UNITED STATES PATENT AND TRADEMARK OFFICE

APPLICATION NO.	FILING DATE	FIRST NAMED INVENTOR	ATTORNEY DOCKET NO.	CONFIRMATION NO.
10/735,602	12/12/2003	Hao-Jan Lin	JCLA10516	1741
23900	7590	01/11/2006	EXAMINER AKHAVAN, RAMIN	
J C PATENTS, INC. 4 VENTURE, SUITE 250 IRVINE, CA 92618			ART UNIT 1636	
DATE MAILED: 01/11/2006

Office Action Summary

DETAILED ACTION

FIG. 2

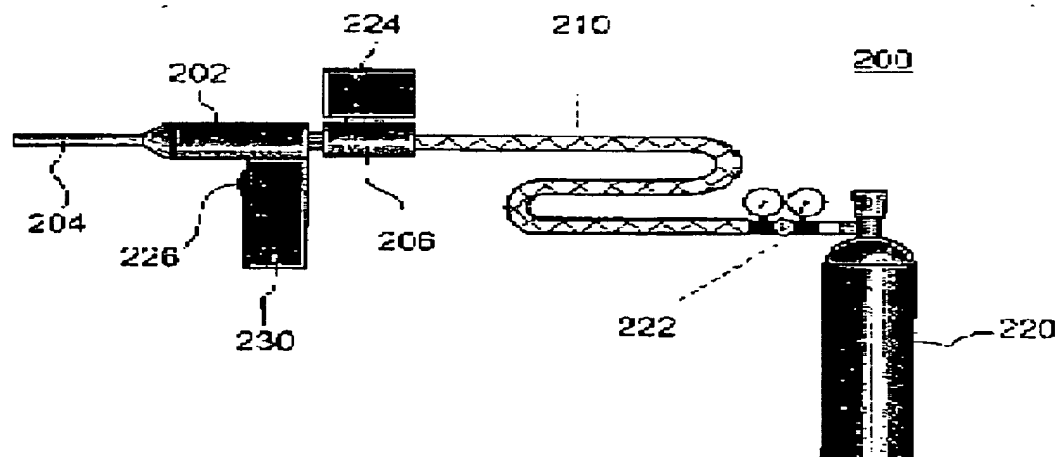
In addition, it is unclear whether “the control” is a structural component of the gene gun apparatus or whether the limitation “the control” is meant to signify an action step taken in practicing the claimed process. The ambiguity is demonstrated by viewing Figure 2 reproduced below:

The structure marked **224** is indicated to be a control valve. The specification further indicates that “the controller” is not pictured thus the figure is not helpful in this regard. (Specification, ¶ 0034; all references to the Specification herein correspond to the published version of the application, i.e., 2004/0180442). The specification provides that “the controller” controls the “control valve **224**”. Thus it is unclear whether “the control” is either an additional component or an additional step that controls the controller. If the limitation “the control” is intended to define the “control valve” the claims should be amended to clarify as such. Alternatively, if “the control” is meant to signify an action step of the “control valve” to regulate “the controller” then the claims should be amended accordingly. However, as written the claims are vague because it is unclear how the claims should be interpreted thus rendering indeterminable the claims’ metes and bounds.
